SUBJECT: ISSUANCE OF AMENDMENT NO. 5 TO FACILITY OPERATING LICENSE NPF-4  
NORTH ANNA POWER STATION, UNIT NO. 1

License No. NPF-4  
Amendment No. 5

SAFETY EVALUATION BY THE OFFICE OF  
NUCLEAR REACTOR REGULATION SUPPORTING AMENDMENT NO. 5  
TO LICENSE NO. NPF-4  
(VIRGINIA ELECTRIC AND POWER COMPANY)

ATTACHMENT TO LICENSE AMENDMENT NO. 5

Figure 3.6-1 Maximum Allowable Primary Containment Air Partial Pressure Versus Service Water Temperature and RWST Water Temperature

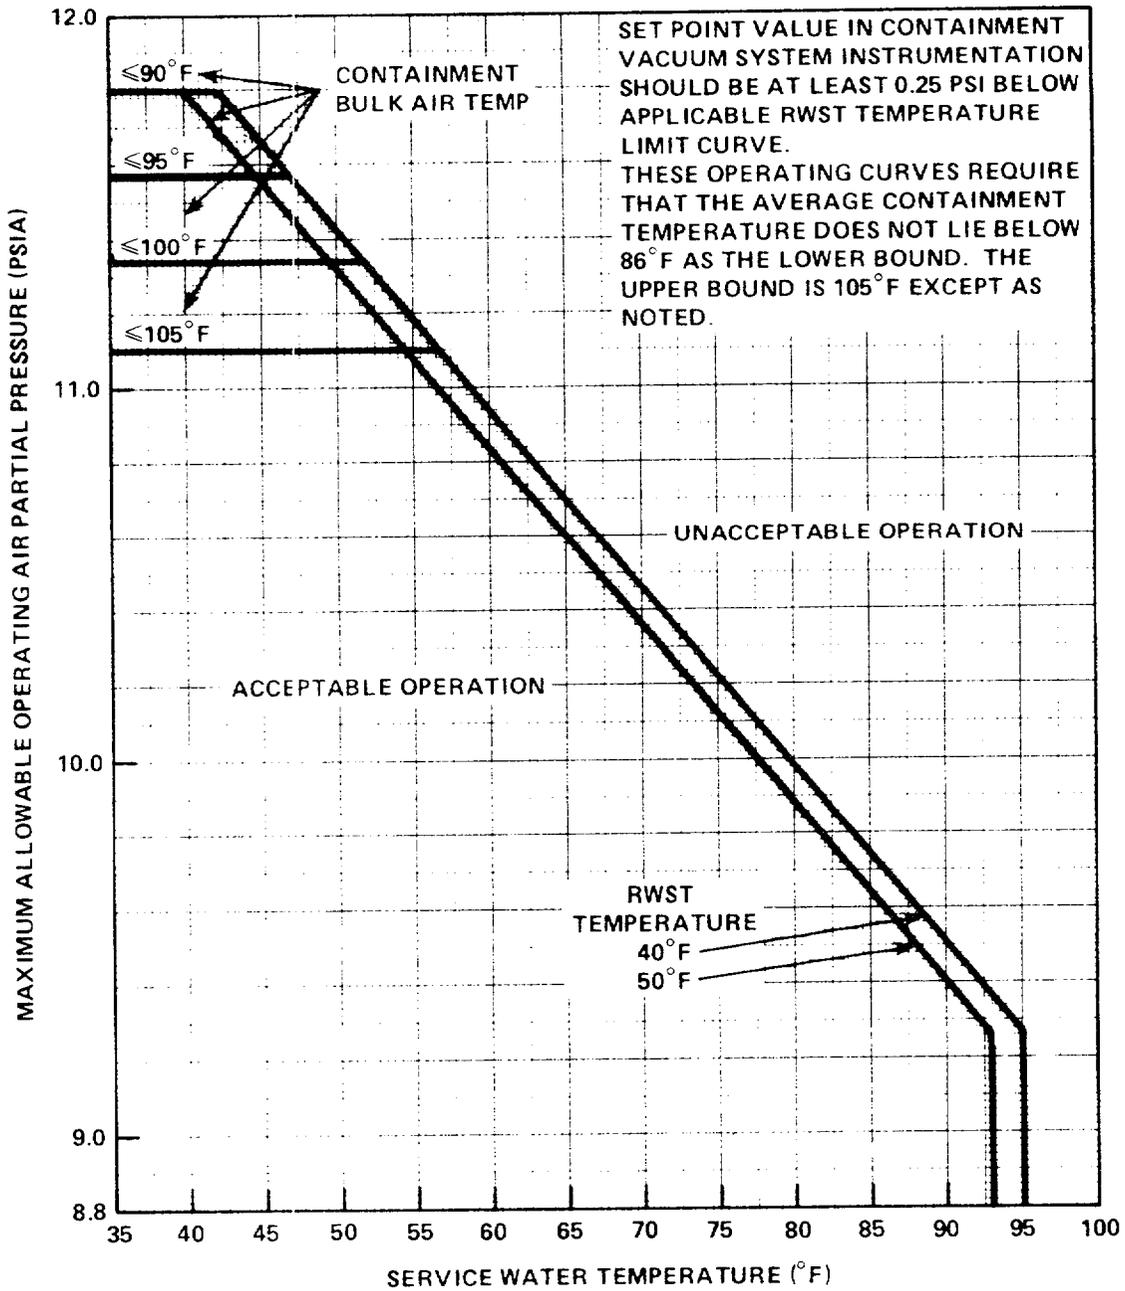
Until Technical Specification 3.1.2.8.b.3, 4.1.2.8.b, 3.5.5.c, 4.5.5.b, 3.6.2.2, 4.6.2.2.1.b, 4.6.2.2.1.c, 4.6.2.2.2, Table 3.6-1, Items 32, 33, 34 and 35 of Item e, Figure 3.6-1 and Table 3.7-4 (snubbers 112 and 113) become effective (1) the refueling water storage tank water temperature shall not exceed 40 degrees Fahrenheit, (2) the service water temperature shall be maintained between 35 degrees Fahrenheit and 80 degrees Fahrenheit, (3) the containment atmosphere temperature shall be maintained between 86 degrees Fahrenheit and 105 degrees Fahrenheit and (4) the containment air partial pressure shall be maintained in accordance with Figure 1 (attached to Amendment No. 3 to Facility Operating License NPF-4) to assure that adequate net positive suction head is available to the recirculation spray pumps.

3.6.1.4 Primary containment internal air partial pressure shall be maintained  $> 8.9$  psia and within the acceptable operation range of the applicable RWST water temperature limit lines and bulk air temperature limit lines shown on Figure 3.6-1.

With the containment internal air partial pressure  $< 8.9$  psia or above the applicable RWST water temperature limit line or bulk air temperature line shown on Figure 3.6-1, restore the internal air partial pressure to within the limits within 1 hour or be in at least HOT STANDBY within the next 6 hours and in COLD SHUTDOWN within the following 30 hours.
